## PEER REVIEW COMMENTS

PROPOSED BURLINGTON QUARRY EXTENSION, NELSON AGGREGATES Co.

DARYL W. COWELL, P.Geo.

Figure 1. Simulated water level showing a spring recession pattern typical of wetlands underlain by low permeability materials (Figure 6.35 for Wetland 13032 in the Level 1 and 2 Hydrogeological Assessment). In this simulation, lowest wetland water levels are not achieved until August – September.

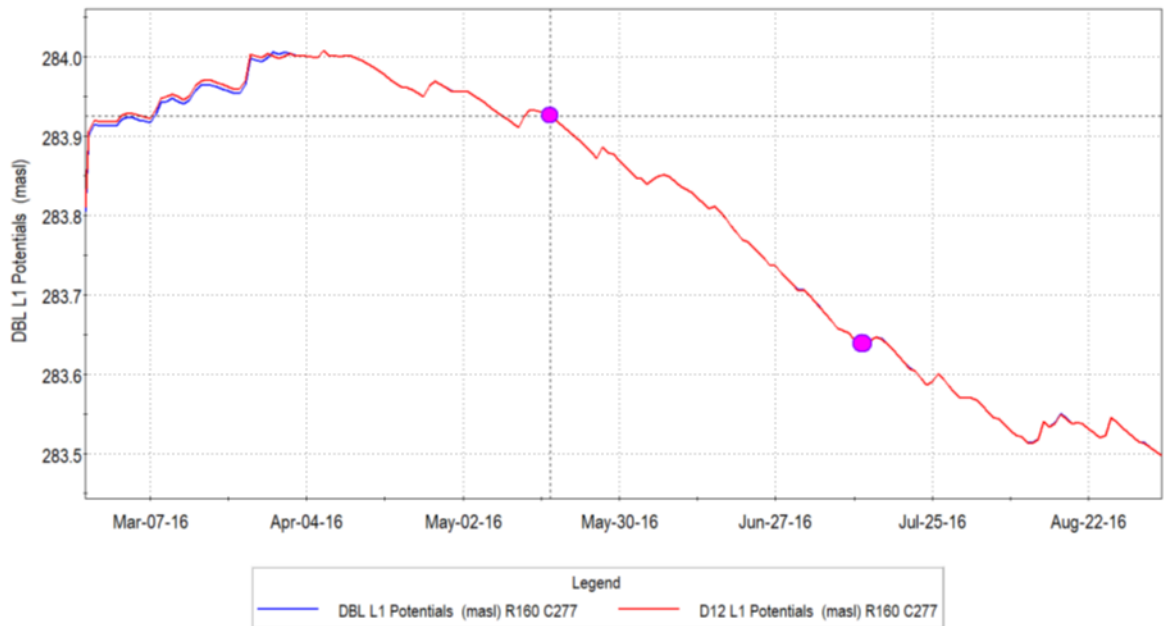
8. A wetland (or pond) underlain by material having a very low permeability should demonstrate a very gradually lowering water level over the course of the hydroperiod assuming the level is not directly supported by underlying aquifer(s). For example, as the till aquifer level declines following snowmelt and spring precipitation, then the surface water level in the wetland should decrease very gradually over the course of the hydrological period potentially being recharged by rainfall but otherwise demonstrating a gradual but continuous decline.

9. This behaviour was, in fact simulated for Wetland 13032 (Figure 1). Following snowmelt and early precipitation from late March through early April, the water level gradually declines, responding only to rainfall events (as shown by each of the slight upticks) through the season reaching annual lows in late July/early August.

10. However, this pattern is not demonstrated in all wetlands located on the site. Table 42 (page 86) in the Surface Water Assessment report indicates that levels in at least four wetlands (SW11/13027; SW12/13022; SW13/13016) and SW16/13201) all reach “0” (based on 0.0 m reading on staff gauge) prior to late May on the 20-year monitoring and most prior to the first week of May. These indicate a pattern of snowmelt/spring precipitation fed systems immediately drying out by relatively rapid infiltration through the underlying till unlike the pattern demonstrated in Figure 1.

Figure 2. Manual water level hydrograph of MP-5, SG-4, OW3-22B as well as at three adjacent wells (OW3-24B, 27B, and MW03-04B). The “Southeast Wetland” of Golder Associates Ltd. (2006) is equivalent to Wetland 17/13033 in the Earthfx (2020) report (Figure 19-50).

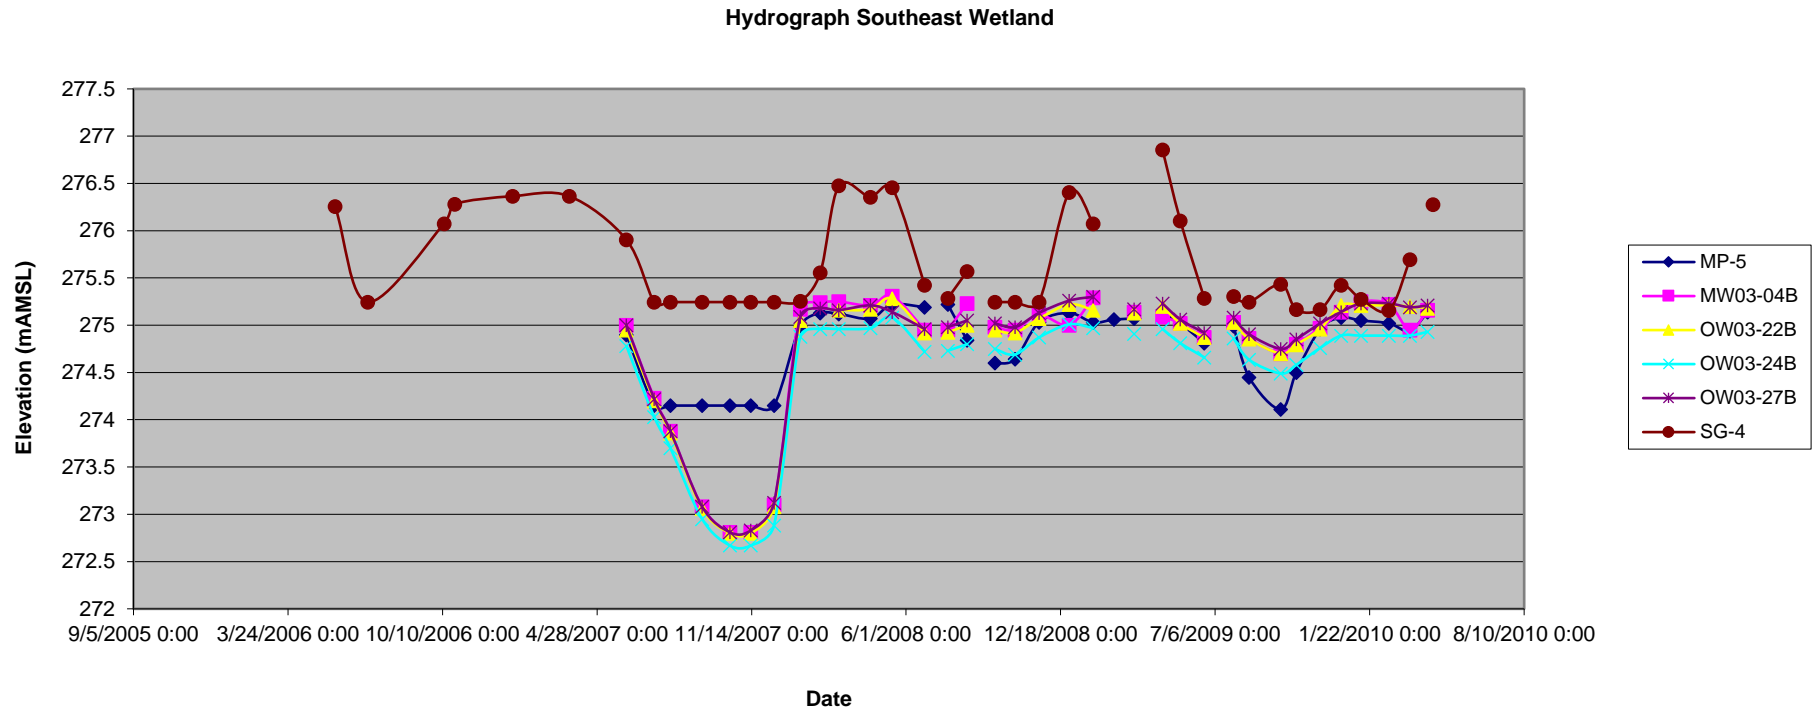
11. Figure 2 indicates that surface waters in the wetland are in fact directly connected to the underlying bedrock aquifer as shown by the precise correlation between the levels in MP-5 and all underlying wells. This behaviour is particularly well marked during the late Spring to early Winter period of 2007. The data are monthly, hence could mask some delay in response, however, such a direct correlation in levels as shown, even over monthly intervals indicate the presence of a direct hydraulic connection with the bedrock aquifer (compare to Figure 2 to Figure 1).

Figure 3: Aquifer pumping test results showing water levels in bedrock wells (OW03), the wetland surface (MP-5), and a staff gauge (SG-2) in the southeast wetland during February 2006 (Golder Associates Ltd. 2006).

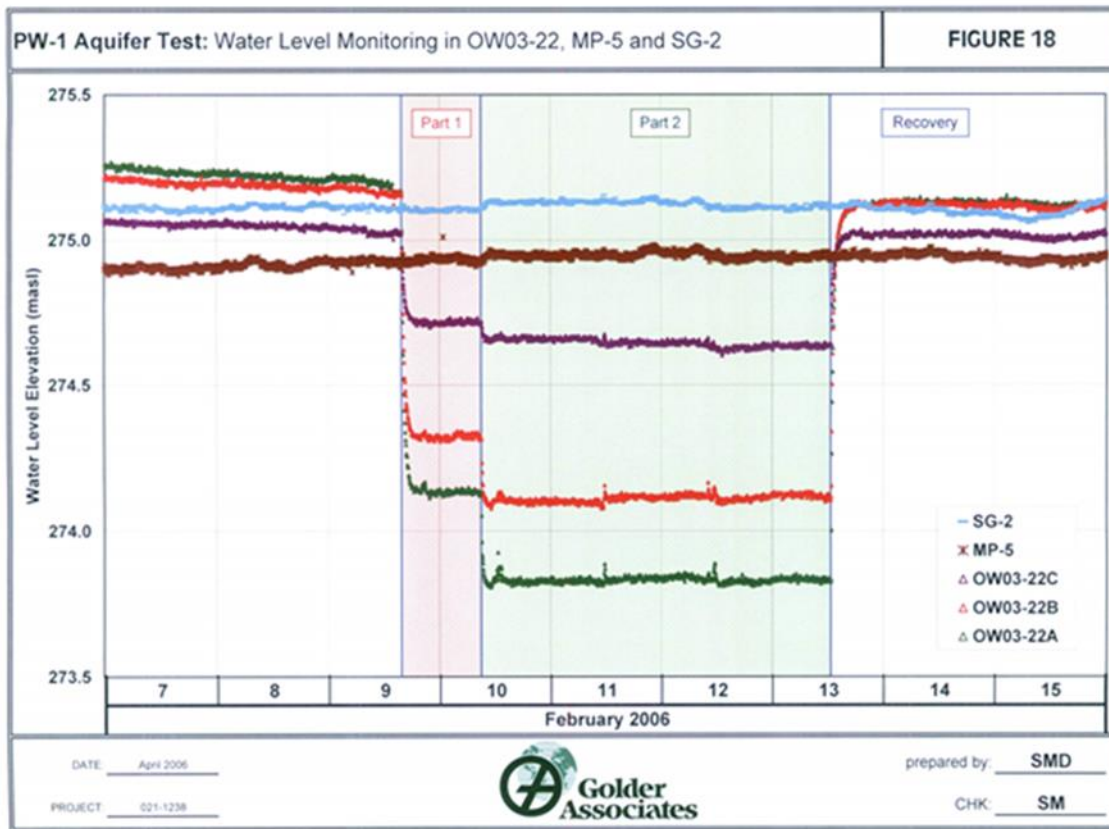
12. Figure 3 shows the results of a 6-day pumping test in bedrock wells located near MP-5 and SG-2 during February 2006. The lack of any evident response in the mini-piezometer and staff gauge (brown and blue lines, respectively) was provided as proof of the aquitard characteristic of the Halton Till. However the next year – 2007 – was a drought year and the full year hydrograph for the wells, mini-piezometer and staff gauge demonstrate a direct connection (Figure 2). It is clear that a 6-day pumping test is not long enough to determine connectivity.

- i. A 30-day pumping test should be conducted in at least 2 wetlands (e.g., 17/13033) to determine degree of connectivity between wetlands and the underlying aquifer.
- ii. Wetland hydroperiods will be impacted during quarrying and prior to excavation lake filling (and potentially after filling depending on final levels). These impacts need to be assessed and potential mitigation measures should be developed.
- iii. The Halton Till layer in the hydrogeological model requires better hydraulic conductivity definition (absolute K values and spatial distribution).

Figure 1a. Location of springs A to K, sinking streams near the quarry, and locations of the photos (circled numbers) shown in Figures 2 to 7.

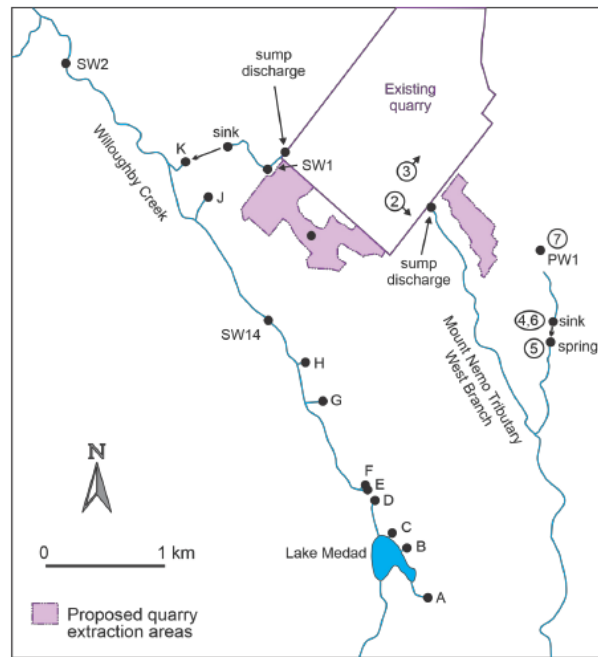
23. Worthington (2006 and 2020) documented the presence and location of 10 springs in the Medad Valley. He provided one-time flow estimates (March 23, 2006) that ranged between 3 and 32 L/S at the time of observation. Springs G, H, J, and K are all within about 1 km of the western extension and spring J is within about 500 m (see Worthington Figure 1a below). These four springs have a combined flow estimated at 45 L/s.

25. In either case, they lie near the base of the valley wall. Spring elevations are not documented but are likely at about 250 m amsl based on visible contour flattening (see Site Plan, Page 2) which is very close to the final quarry floor at 252.5 m. The springs are approximately 20 m below the top of bedrock at the northwest corner of the western extension but will be only a couple of meters below the proposed quarry floor.

26. The northwest corner of the western extension quarry is within 200 m of the base of the Medad Valley wall, thus yielding a pre-development hydraulic gradient in the order of 1:10 and post-development gradient of 1:80; an approximately eight times shallowing of the groundwater surface. Spring J would have a pre-development hydraulic gradient in the order of 1:25 and spring K about 1:50: both well above the post-development condition.

- i. Continuous spring flow monitoring should be undertaken for (at least) Medad Valley springs C, G, H, J and K commencing at least 2 years prior to quarrying in the western extension and throughout the period of rehabilitation.
- ii. Monitoring should include flow, temperature, conductivity and suspended solids, at a minimum, and be added to the AMP with designated targets and contingency triggers and response.
- iii. A detailed potentiometric surface should be provided.
- iv. Dye trace(s) should be conducted between boreholes in the western extension and the same springs noted above in recommendation #1.
- v. Following quarrying, the western extension should be rehabilitated to lakes.

Figure 2. A portion of Figure A7 (Borehole BH06-1) from Worthington (2020).

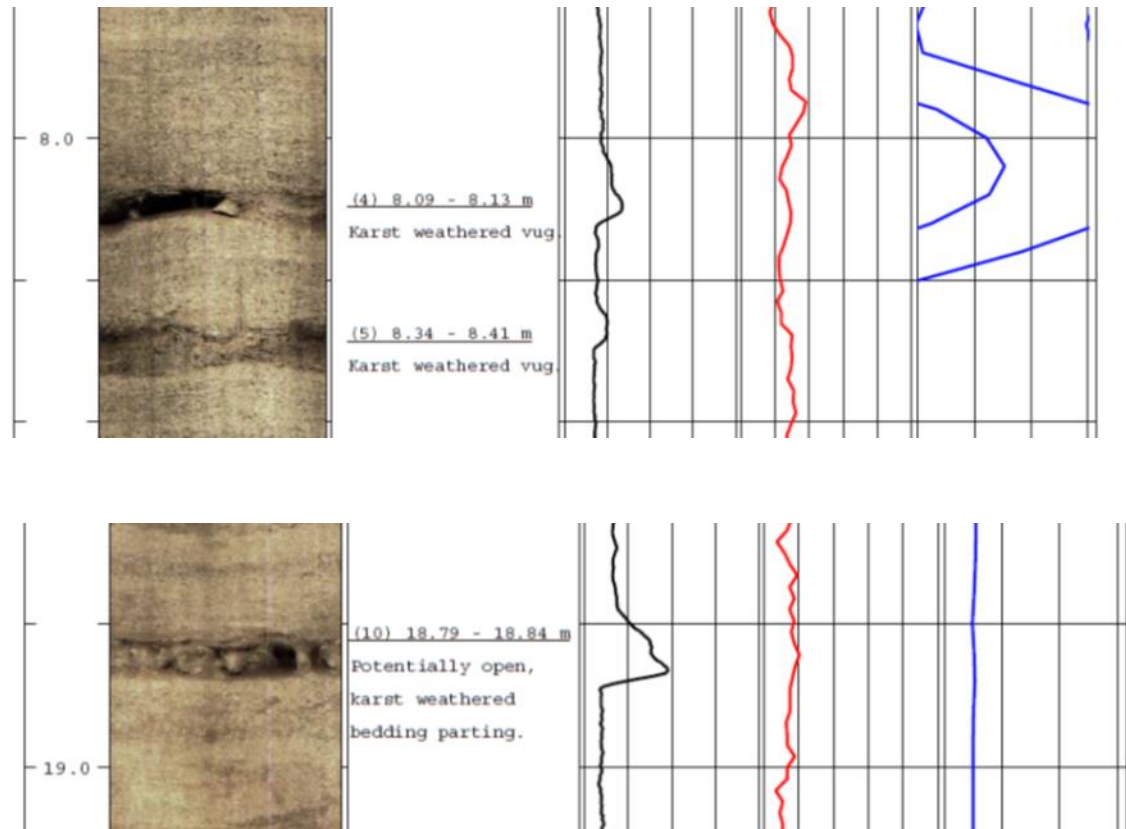
32. Worthington (2006) mapped and traced karst conduit systems to the south (West Tributary) and north (Willoughby Creek – spring K). The latter indicates that karst conduits directly feeding the Medad Valley springs are, in fact, present. He did not observe sinkholes within the western extension area (Worthington 2020), however, his Figure A7 (partially reproduced below) indicates the presence of “Karst” weathered vugs along bedding planes in borehole BH06-1. These are found at 8.09 m, 8.34 m and 18.79 m below ground surface adjacent to the southern extension area.

33. The uppermost vug is particularly interesting being up 4 cm wide and open. It also shows a significantly higher specific conductivity (blue vertical line) than the remainder of the core indicating the presence of carbonate-rich water.
34. Borehole BH06-1 is located northeast of the proposed southern extension. The continuity and extension of these “vugs” are not fully known but at least the uppermost vug provides indications of water transmission which suggests some continuity. This is confirmed by the

flowmeter results from wells OW-03-30 and OW-03-31 (Worthington Figures A8 and A9) which show strong flows in the 7 to 8 mbgs depth.

35. The final quarry floor in the western extension will be at an elevation of 252.5 m amsl which is well below the elevations of all three of the “karst-weathered” bedding planes.
